Event # 47842

PART 21 REPORT - SWAGELOK U SERIES BELLOWS VALVES LOOSENING OF STEM TIPS

**Subject: Potential 10CFR21 notification**

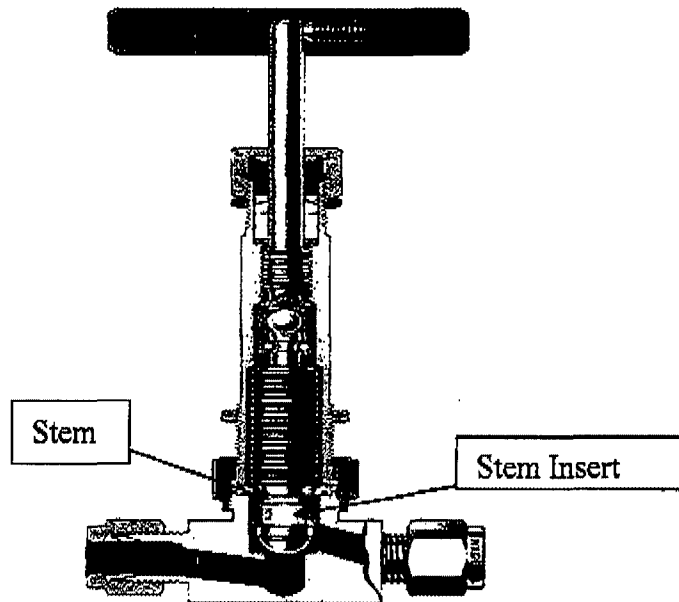
Swagelok received a return from Duke Energy for two 8U series bellows valves for investigation of stem tips that had loosened during performance testing of equipment.

Our evaluation confirmed loosening of the stem tips and determined the root cause to be higher than normal torque being applied to the valve handle during closure. *(Please note that we did not specify a minimum or maximum torque for our operating instructions.)* This caused the stem and the stem insert interface to loosen, but not fully disengage. Our tests show that closure to catalog specification of  $4.0 \times 10^{-9}$  atm. cc/sec of helium can still be achieved with this condition.

The picture above shows a cutaway version of a valve in question.

**Tolerance stack-ups between the stem and stem tip for the 8U Series valve**

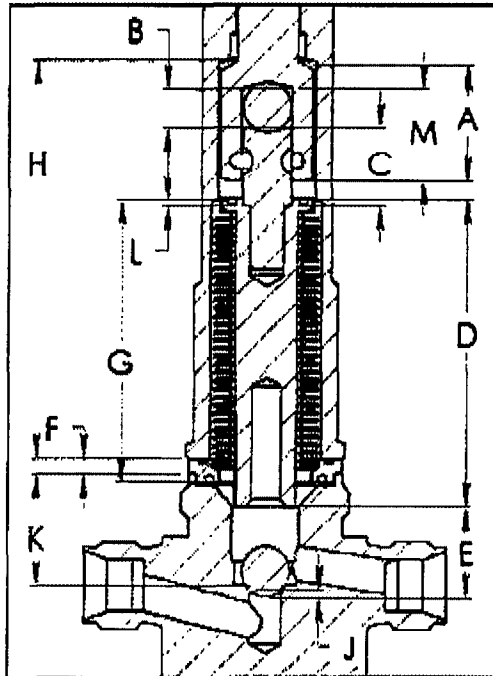
Although the stem tip may loosen when higher than normal torque is applied to close the valve, the tip will not become completely disengaged from the stem insert. The document below shows the stack up of tolerances on the 8U valve, with a loose stem tip. Even with the tip loosened until it contacts the valve body, at least one thread of engagement still remains between the tip and stem insert. This means the stem tip will remain captured within the valve body and will not enter the process stream. Similar conditions apply to the 4U and 6U Series valves.

<b>MAX STROKE</b>	<b>0.1755</b>
<b>NOM STROKE</b>	<b>0.1207</b>
<b>MIN STROKE</b>	<b>0.0959</b>

distance of stem adapter flat to top	0.270
distance of stem adapter flat to top- Max Stroke	0.0945
lead in to threads on stem adapter	0.026
threads per inch on adapter	24.0000
number of threads engaged at max stroke with loose stem (28E-29E*30E)	1.64

The continued engagement of the stem threads also means that the valve can be shut off, even if the threads had loosened. We have tested several conditions of the loose stem tips and confirmed that closure to catalog specification of  $4.0 \times 10^{-9}$  atm. cc/sec of helium can be achieved.

Revised drawings will be created for the affected utilities, showing both the recommended and maximum allowable closure torques, for the affected valve series.
